United States Patent and Trademark Office

APPLICATION NO.	FI	LING DATE	FIRST NAMED INVENTOR	ATTORNEY DOCKET NO.	CONFIRMATION NO.
10/811,253	03/25/2004		Chris A. Adamini	5702-00020	1639
7:	590	03/23/2006		EXAMINER	
Laurence C. E	Begin		TO, TOAN C		
510 Highland A	venue		ART UNIT	PAPER NUMBER	
PMB 403 Milford, MI 4	18381			3616	THER NOMBER
				DATE MAILED: 03/23/200	6

DETAILED ACTION

Figure 1 of Takahashi et al is attached below for better illustration of the examiner's interpretation.

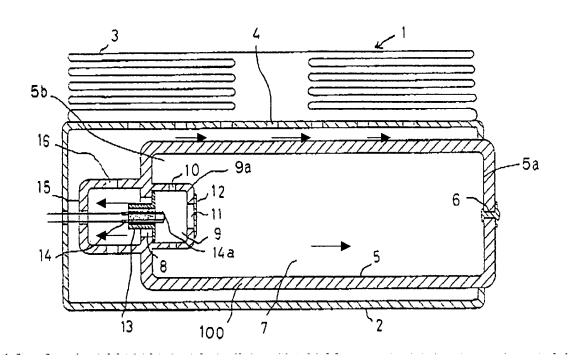
With respect to claims 24-26, Takahashi et al discloses a gas generator for a vehicle occupant protection system comprising: a housing (2); a plurality of chambers (chamber within the diffuser 15, chamber between the inflator housing 2 and container 5, chamber 9, chamber within container 5) formed within said housing, wherein each of said chambers fluidly communicates with at least one other chamber, whereby the chambers are formed to establish opposing fluid flow in each adjacent chamber (see attached figure 1 below) upon gas generator activation (fluid flow in the chamber of diffuser 15 is opposed to fluid flow in the chamber between the housing 2 and container 5); wherein, the gas generator comprising four substantially parallel chambers (chamber within the diffuser 15, chamber between the inflator housing 2 and container 5, chamber 9, chamber within container 5) extending in said housing.

Arrows in the chambers indicated directions of fluid flow
